BRISTOL, VIRGINIA INTEGRATED SOLID WASTE MANAGEMENT FACILITY

STAGE II LANDFILL GAS COLLECTION AND CONTROL SYSTEM EXPANSION

CONSTRUCTION PLANS

FEBRUARY 18, 2025
ADDENDUM 1: APRIL 7, 2025

DRAWING NO. E6

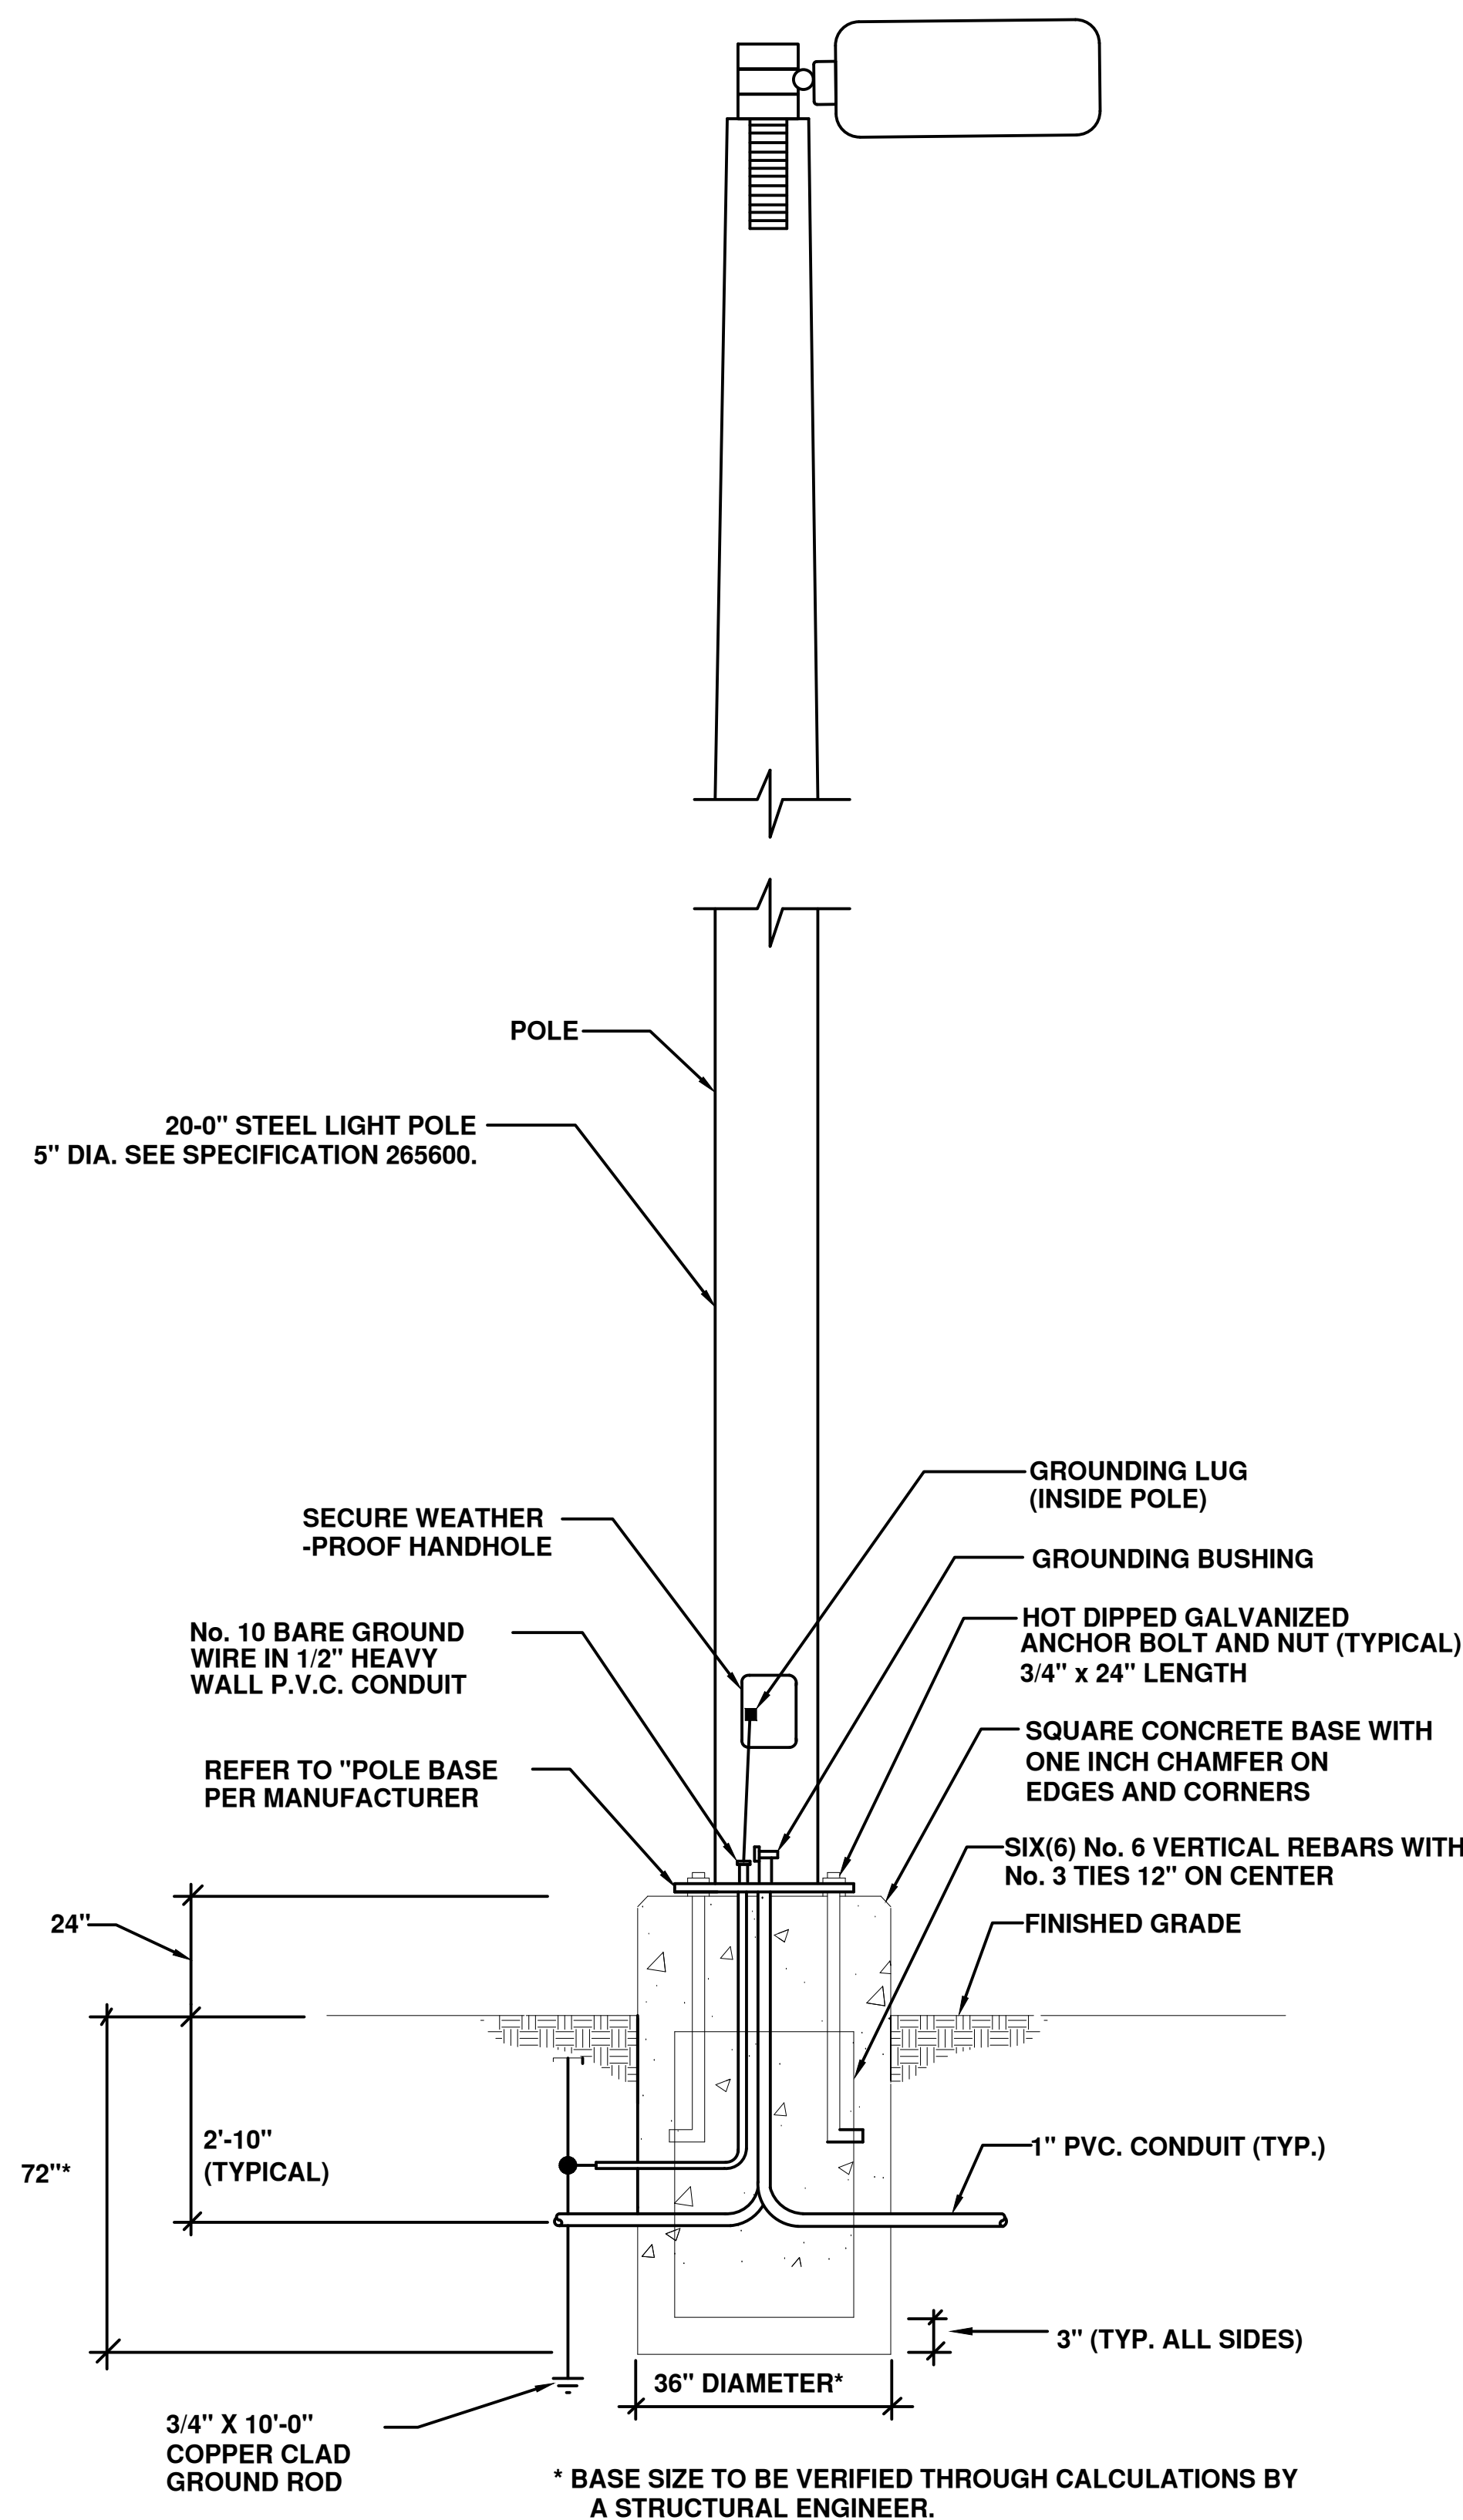
SCS ENGINEERS COMMENT 02/13/25:
DETAIL 6 ON SHEET E7 WILL NOT BE
USED FOR THE STAGE II LFGCCS
EXPANSION PROJECT.
